Trees and Construction

BS5837:2012 Tree Survey, Arboricultural Implications Assessment & Method Statement

Site: Land at Roundwood Road, Wythenshaw,
Manchester, M22 4SB;

Ref: 19196/A2_AIA/AMS

Tree Constraints Plan
Scheme Overlay

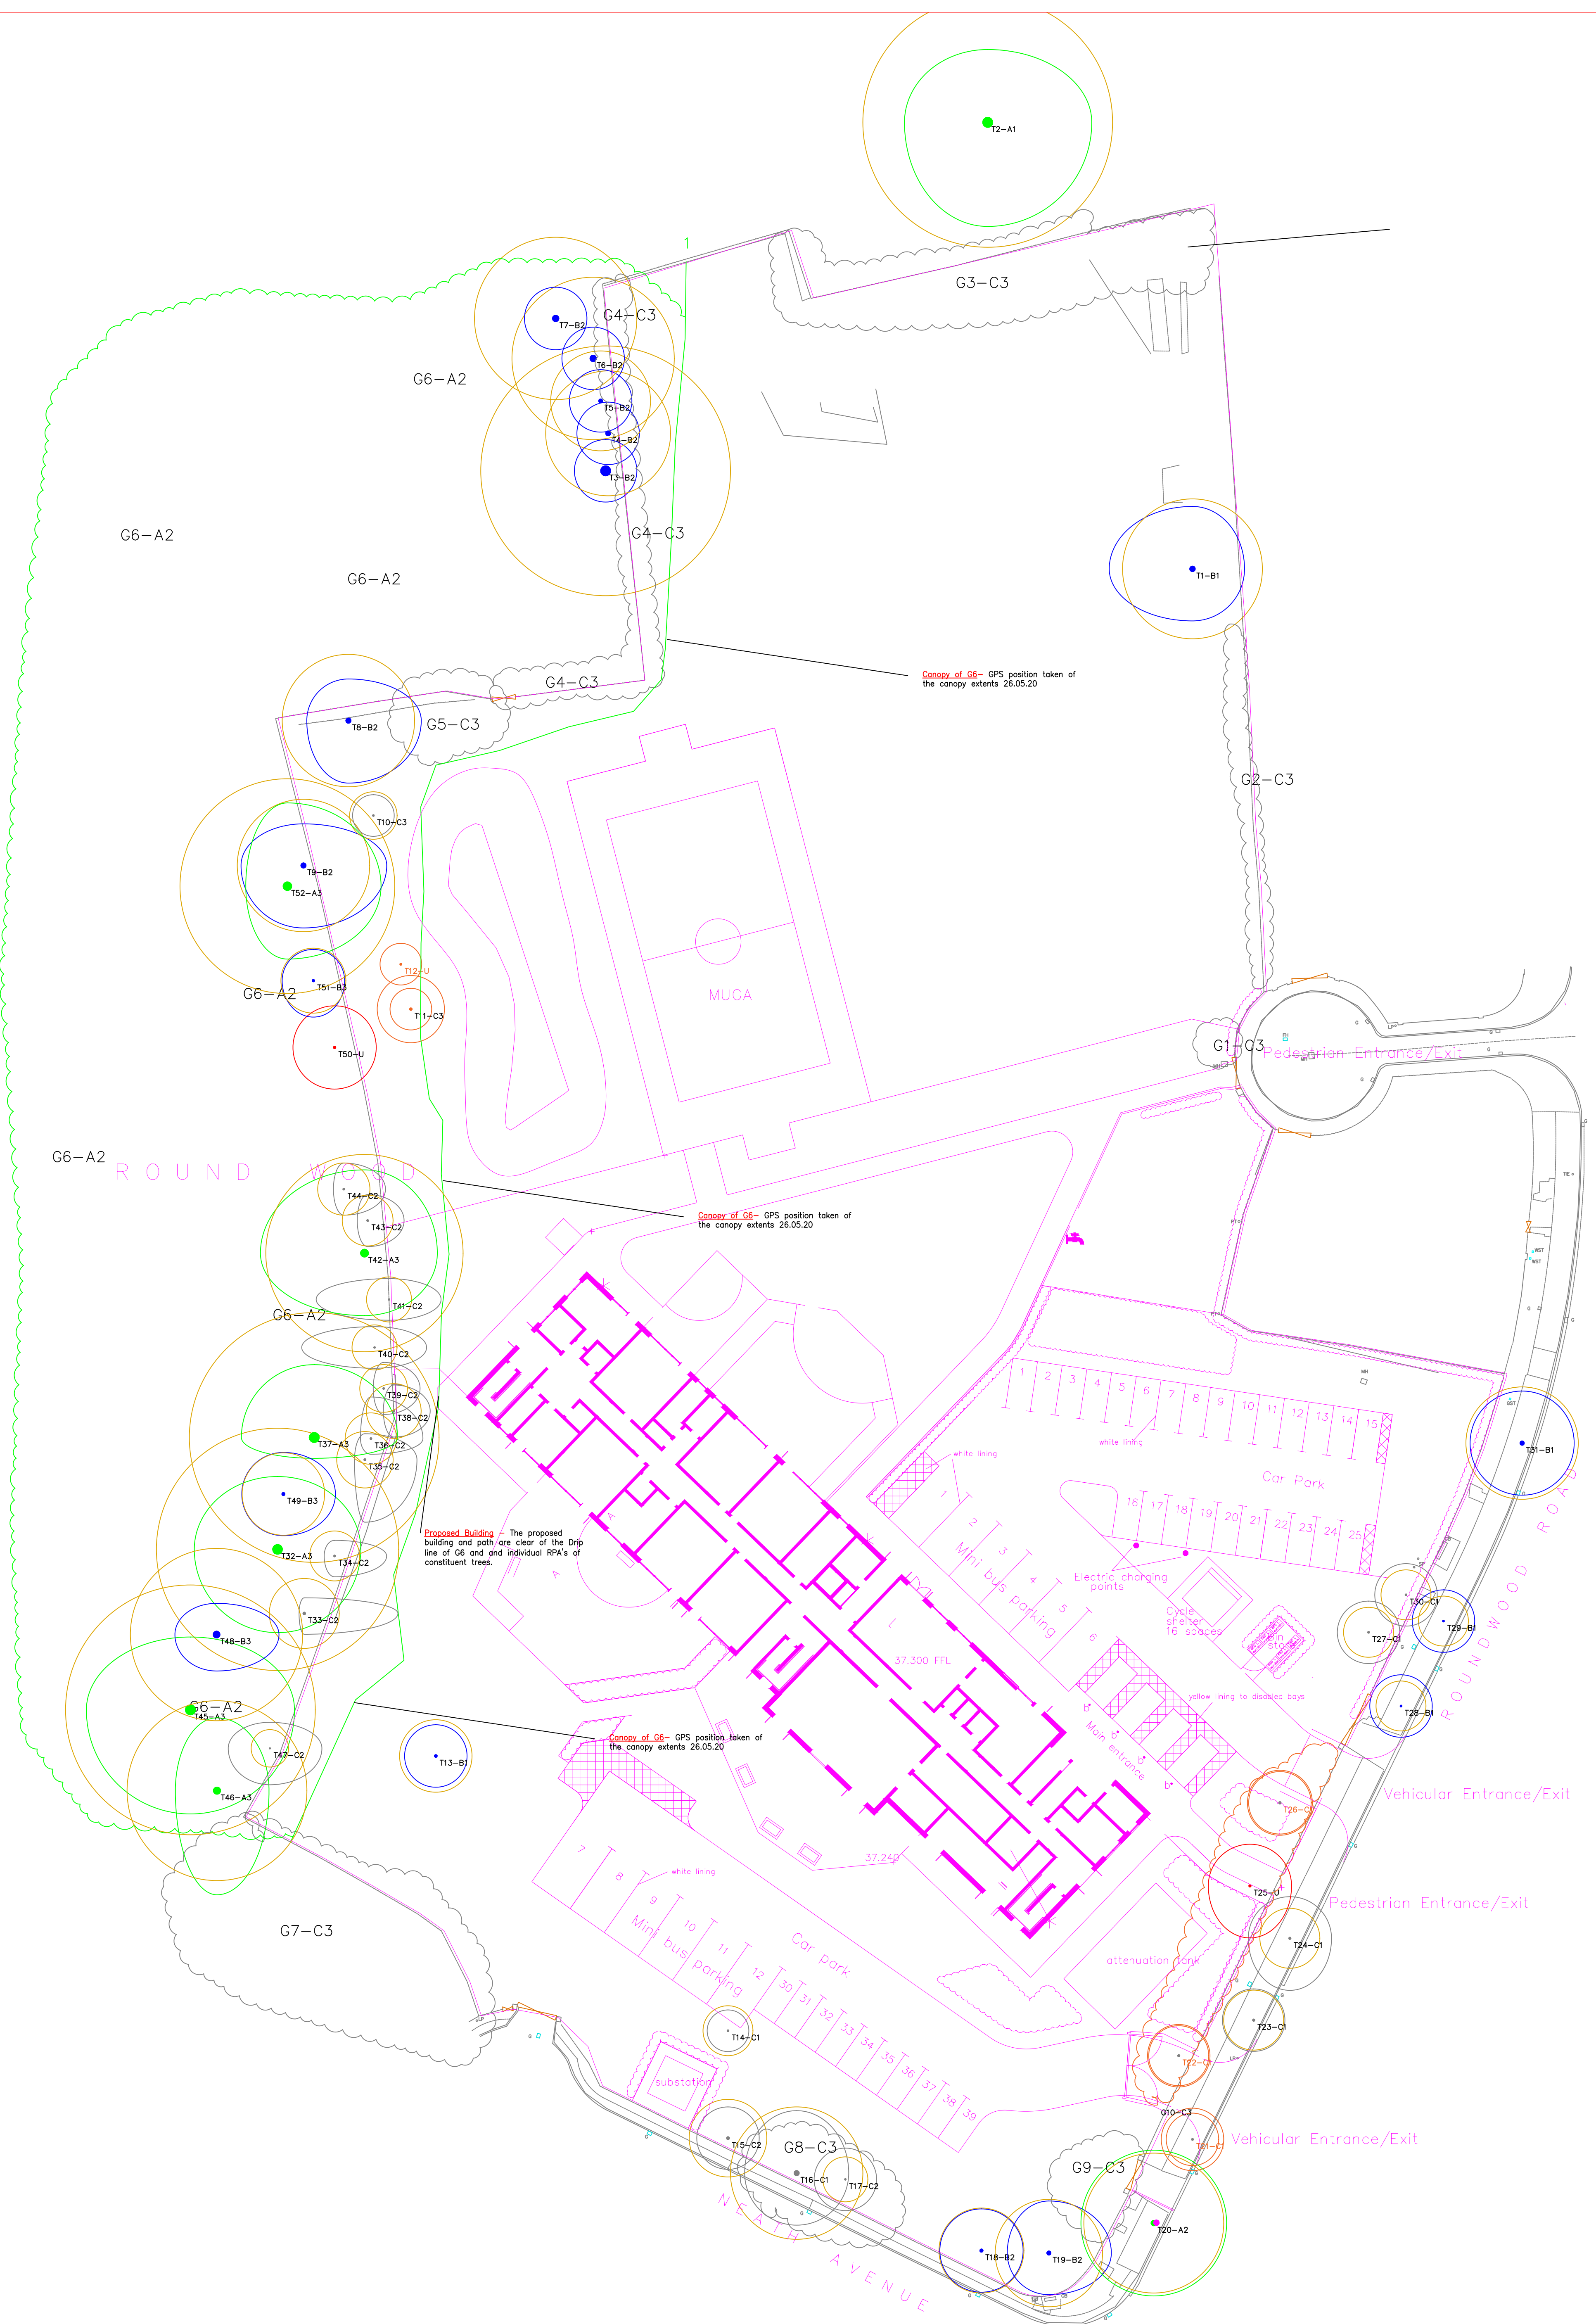
NOTE.1: *For the new boundary fence arrangement*, the removal of G1, G2, G3, G4, G5, G7 and G10 will be required

The loss of trees of this scale and remaining life will have little impact on the site's canopy cover, and little/no impact on the long term amenity. However, this will require mitigation tree planting. These trees are only considered to require 1 : 1 replacement, as is also considering of the site's high volume of trees and dense boundary canopy cover.

NOTE.2: Thereafter, the remaining 'C' category trees are clear of the scheme will be protected by avoidance, staged works and temporary tree protection site hoarding / barrier fences.

NOTE.1: *For the new site access*, RE: the street tree 'Lime' (see; TCP scheme overlay) The new proposed site access is clear of T20 and it can successfully be retained by avoidance and protective fencing as per the TPP

- 3.3.5 The proposed building and hard surface treatments are outside of the RPA's of trees within G6 T31 - T52 therefore once the tree protection is in place as per the TPP there should be no restrictions on operations outside of this area. The only operations envisaged are boundary and internal fencing. This is to be carried out by hand in the landscaping phase and only when construction is complete.
